CERTIFICATE OF APPROPRIATENESS

Property: 1226 Heights Boulevard, Lot 19, Block 187, Houston Heights Subdivision. The property is a vacant 7,500 square foot (50' x 150') interior lot. Currently, the new two-story house approved by HAHC in July 2013 is partially completed.

Proposal: New Construction – Revision to COA for New Construction that was approved in July 2013.

PORCH LOCATION

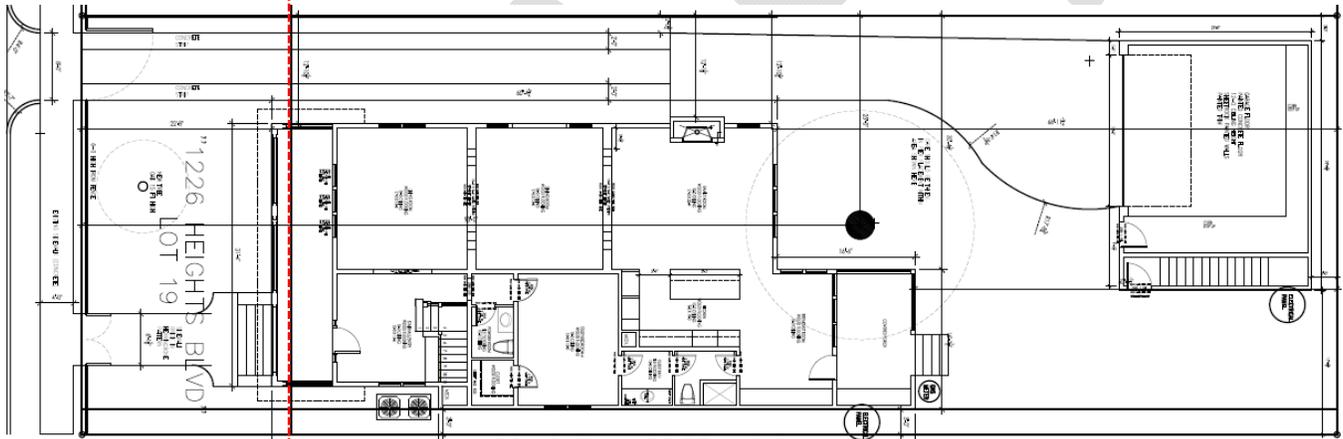
In December 2013, city staff became aware that the partially constructed house (framing and foundation only at that time – see p. 18) was built 2.2' forward of the approved location, which would put the front porch over the required 25' front building line when completed. A 25' front setback is required on Heights Blvd, which is a Major Thoroughfare. The error occurred because the construction crew measured the 25' front building line from a fence on the property instead of from the actual property line.

Staff is recommending denial of both options. The house should be moved to the approved location in order to correct the problem. The setback violation is the result of the applicants' error, and the applicants continued to finish the house after becoming aware of the problem.

OPTION #1

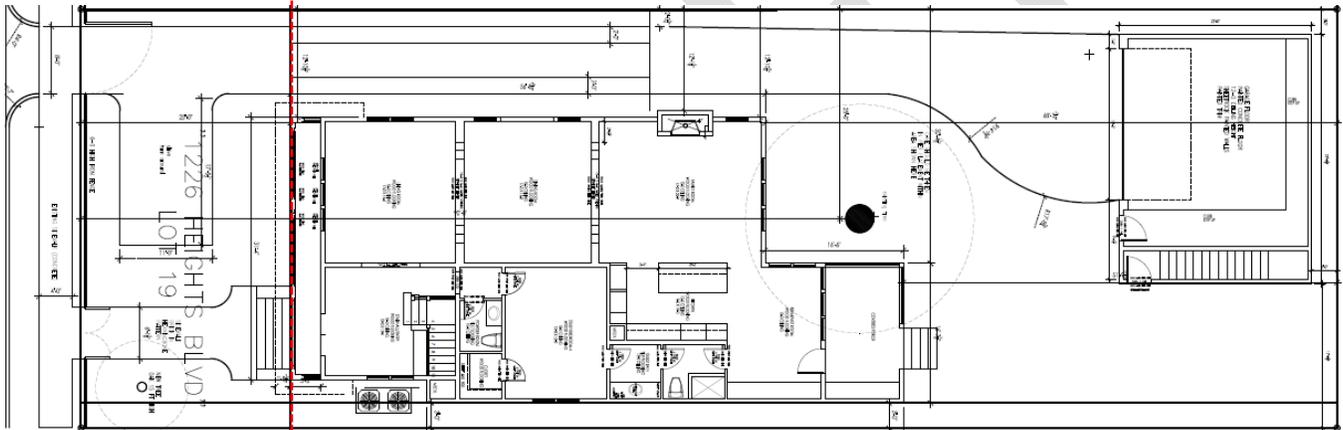
- OPTION #1 does not meet this Criterion. The proposed reduced porch depth of 3'-8" is not functional or typical to the district. Contributing historic houses in the Houston Heights Historic District East feature functional porches with depths of at least 6'-0". A porch with a depth less than 6'-0" would not be functional and therefore not typical.*

OPTION #2

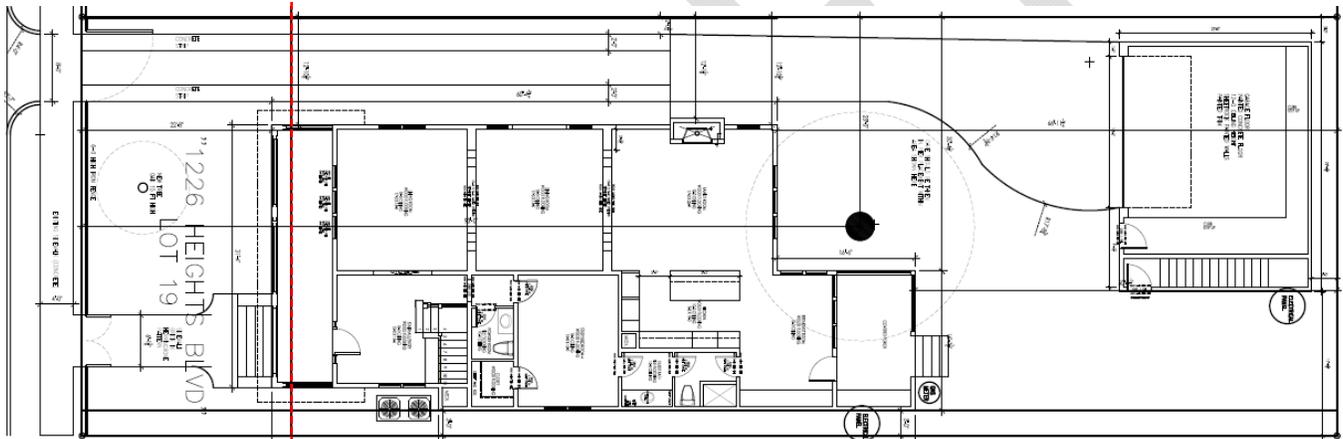
- (1) The new construction must match the typical setbacks of existing contributing structures in the historic district
- OPTION #2 does not meet this Criterion. All contributing buildings on this block of Heights Blvd are located at or behind the required 25' building line (see p.17). Encroaching on the 25' building line would put this structure out of line with the other contributing structures on this block of Heights Blvd, including the neighboring contributing historic residence at 1230 Heights Blvd.*

- Next door is a noncontributing building that is built well within the required 25' setback. This existing nonconformance should not be used as justification for a reduced setback for 1226 Heights Blvd. This noncontributing building could be demolished at any time and new construction would be required to be set back 25'. Also, Criterion 1 requires new construction to match typical setbacks of existing contributing structures. Noncontributing structures are not considered.*
